**41 FROGNAL
LONDON NW3 6YD**

**SUMMARY DESIGN DOCUMENT
NOVEMBER 2015**

The following proposals have been developed by KSR Architects, in conjunction with the other consultants listed below, on behalf of our client and owner of 41 Frogmal NW3 1AW. This application follows on from the previously consented scheme submitted in March 2015 (2015/2026/P) which was consented on 6th August 2015.

PROPOSED FRONT ELEVATION

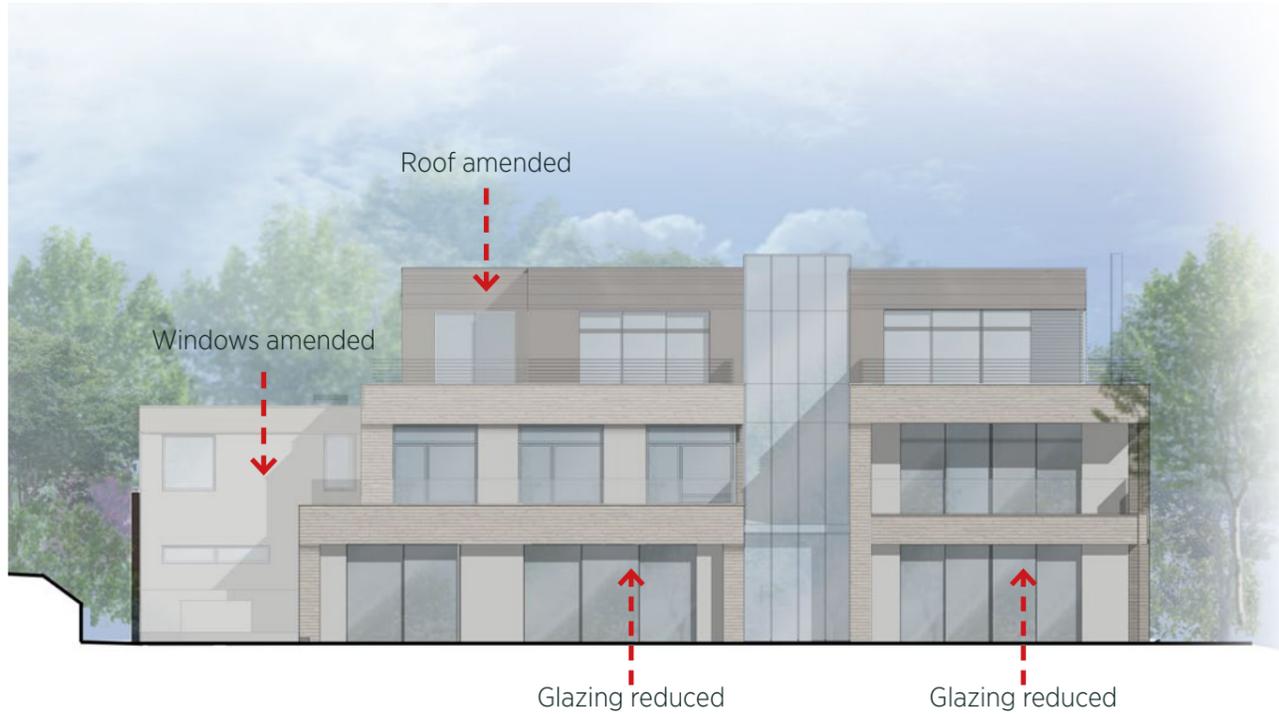
2. There are some minor alterations to the side and rear facade design which relate to changes to internal room layouts and facade detailing. These changes are identified on the comparison elevations and plans.

PROPOSED SITE & LANDSCAPE PLAN

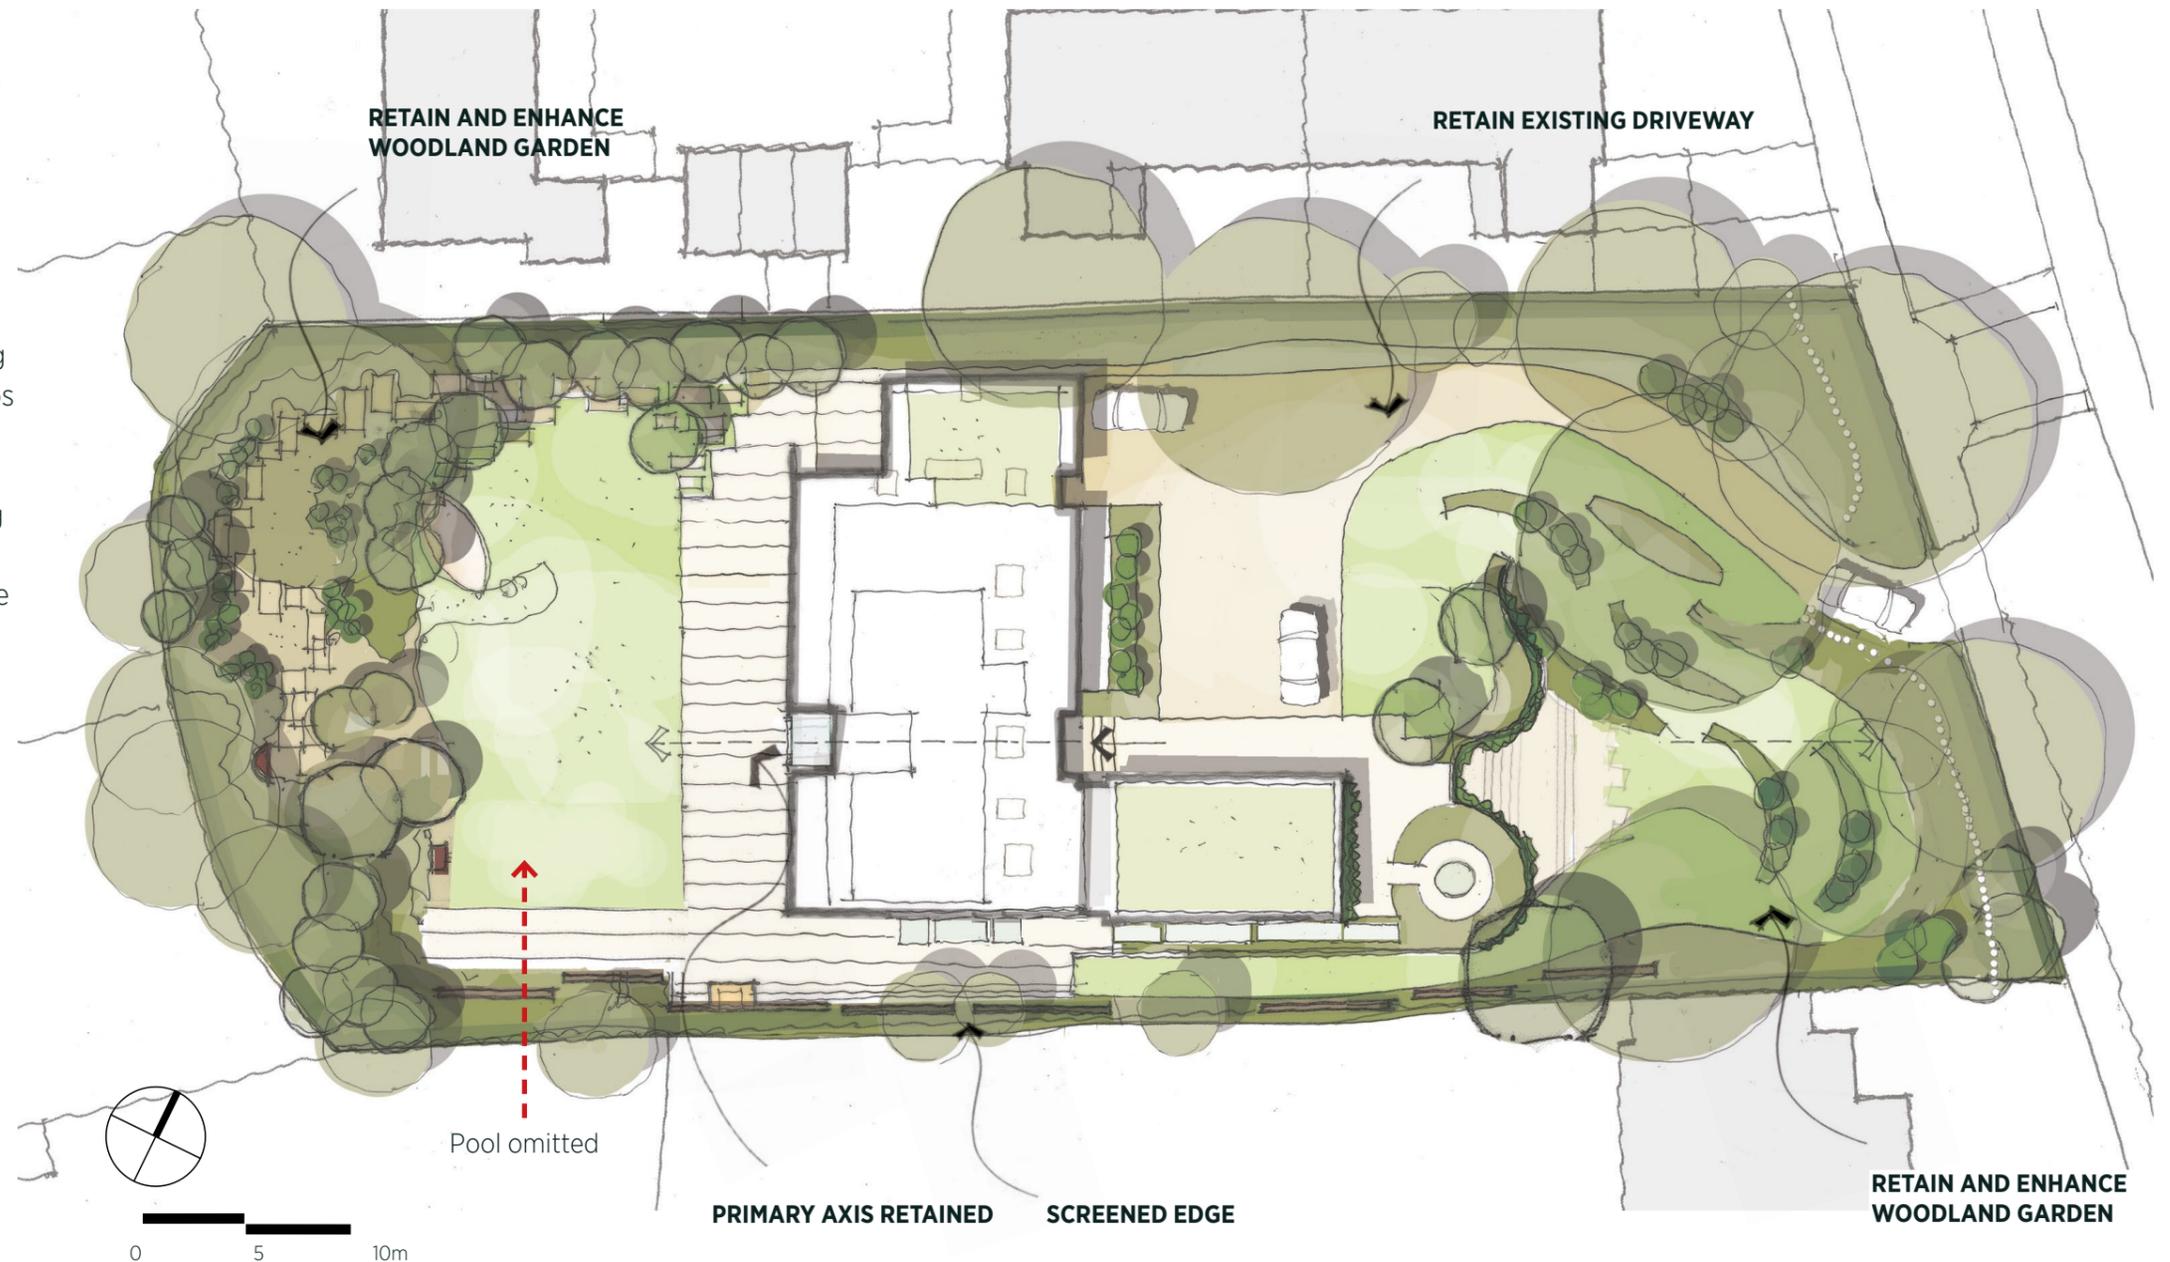
The landscape design remains unchanged from the consented scheme with the exception of the omission of the external pool located in the rear garden.

MATERIALS AND FINISHES

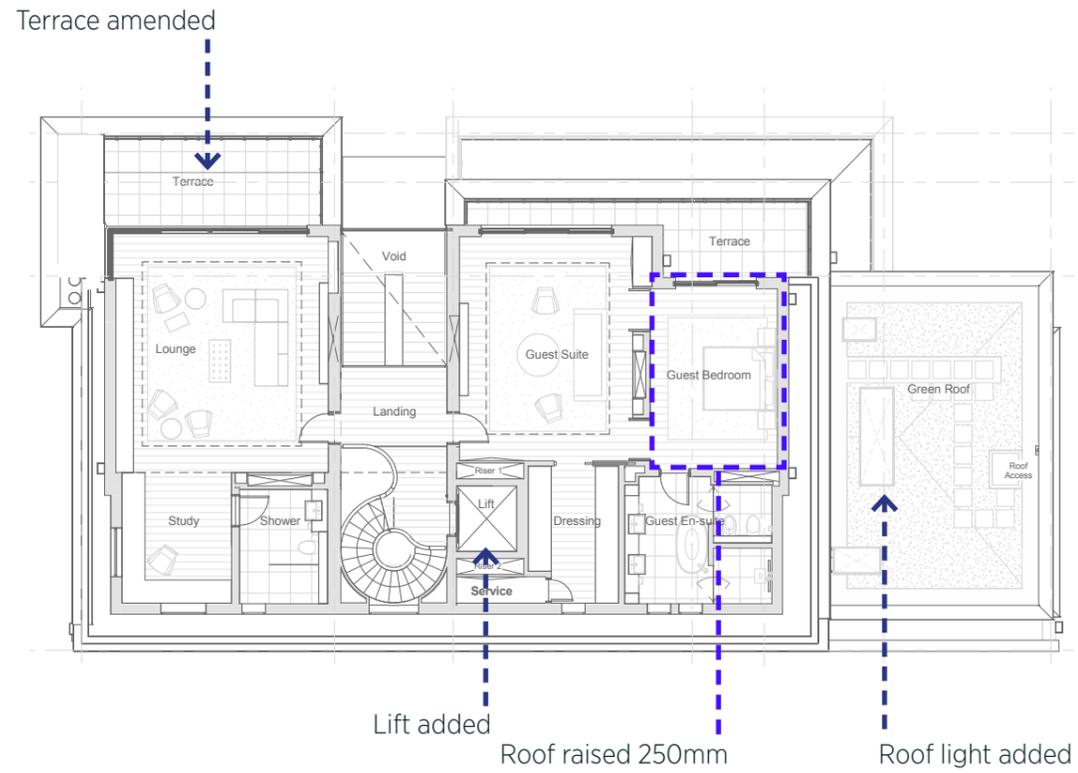
The materials and finishes of the proposed building remain the same as the consented scheme which were selected to compliment the retained existing front facade whilst also being sympathetic to the local area. However, the extent of render to the rear and side facades has been reduced in favour of replicating the use of brick from the front facade, providing a more sympathetic and durable solution.

FIRST FLOOR PLAN
SCALE 1:200

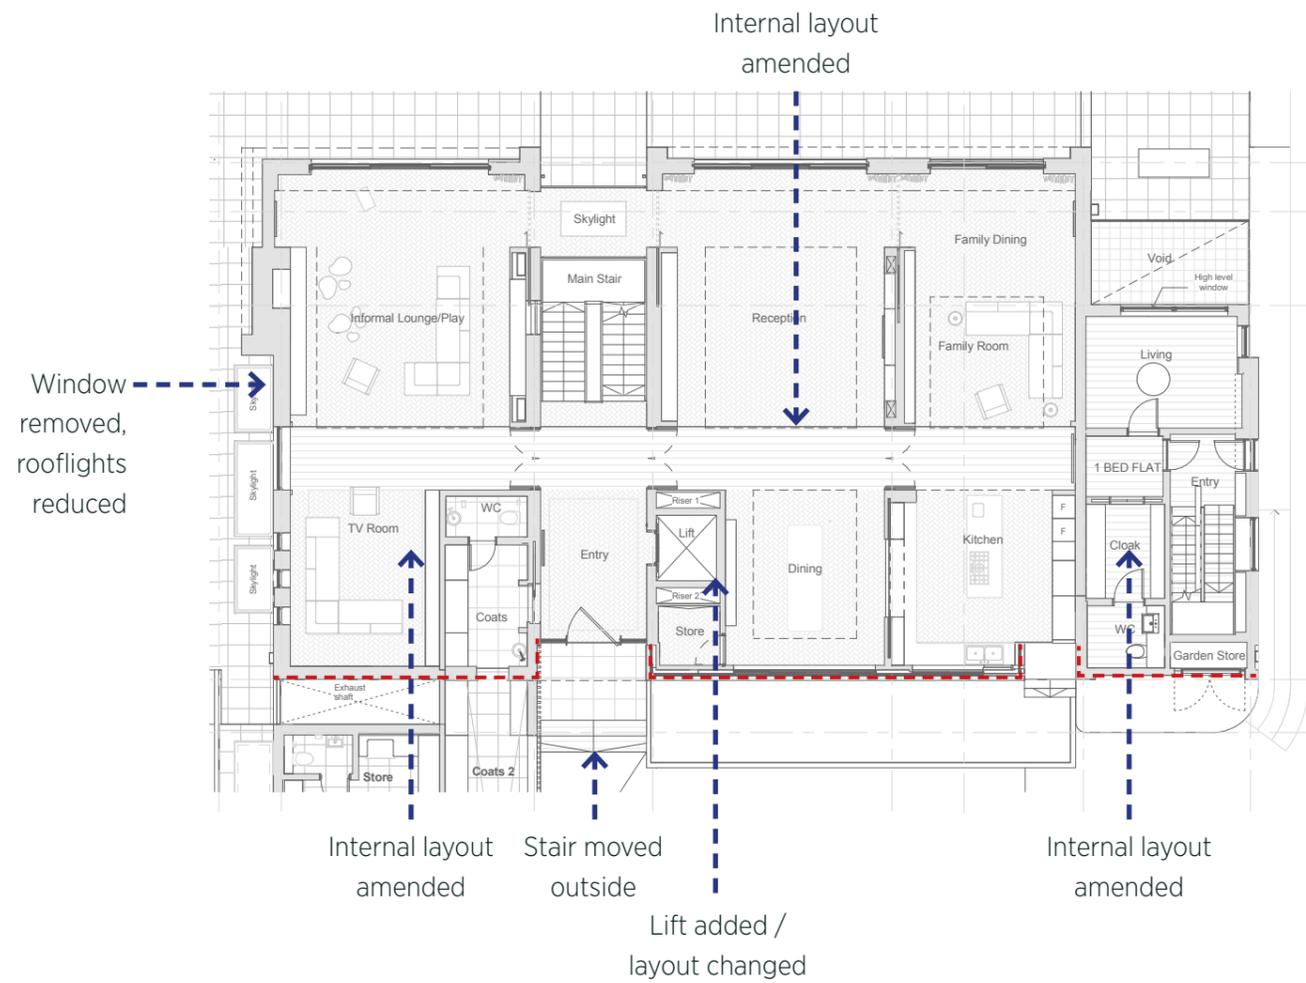
1. The existing front facade is retained as in the current consented scheme. This proposal is for demolition and new build behind the retained front facade. This small change from the consented scheme results in removing the internal first floor slab which was to be partially retained in the consented scheme design. This is to ensure consistency and quality of construction, and the highest energy efficiency by eliminating cold bridging.

LOWER GROUND FLOOR PLAN A
SCALE 1:200

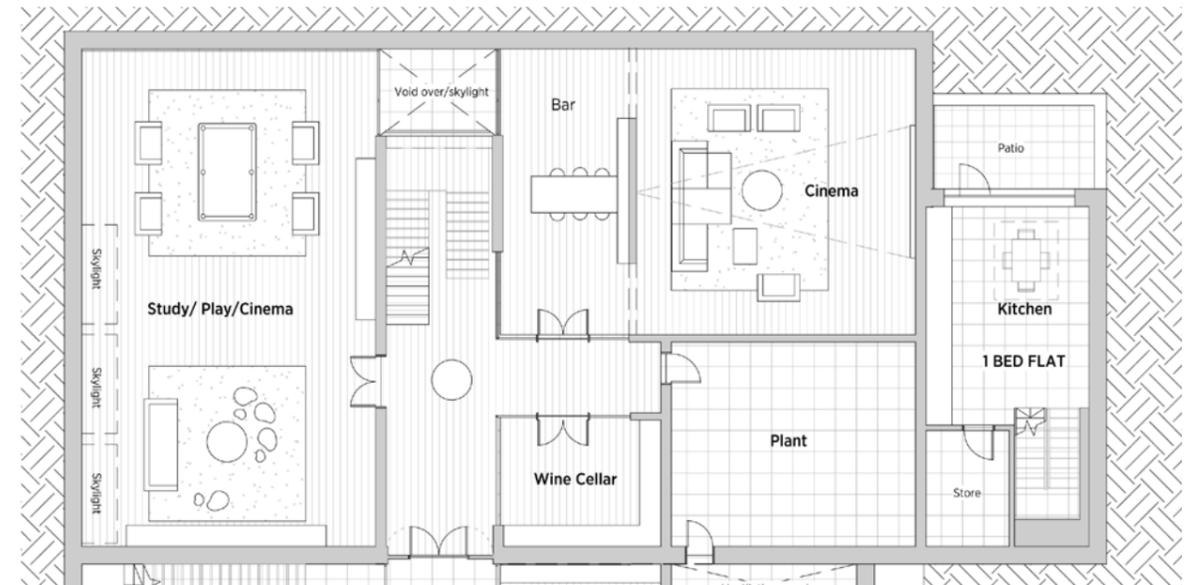
3. The external pool has been omitted. Otherwise, the landscape design is unchanged.
4. The basement level is approx 0.5m lower due to the step down at the ground floor entrance. The footprint of the basement remains the same as the consented scheme.
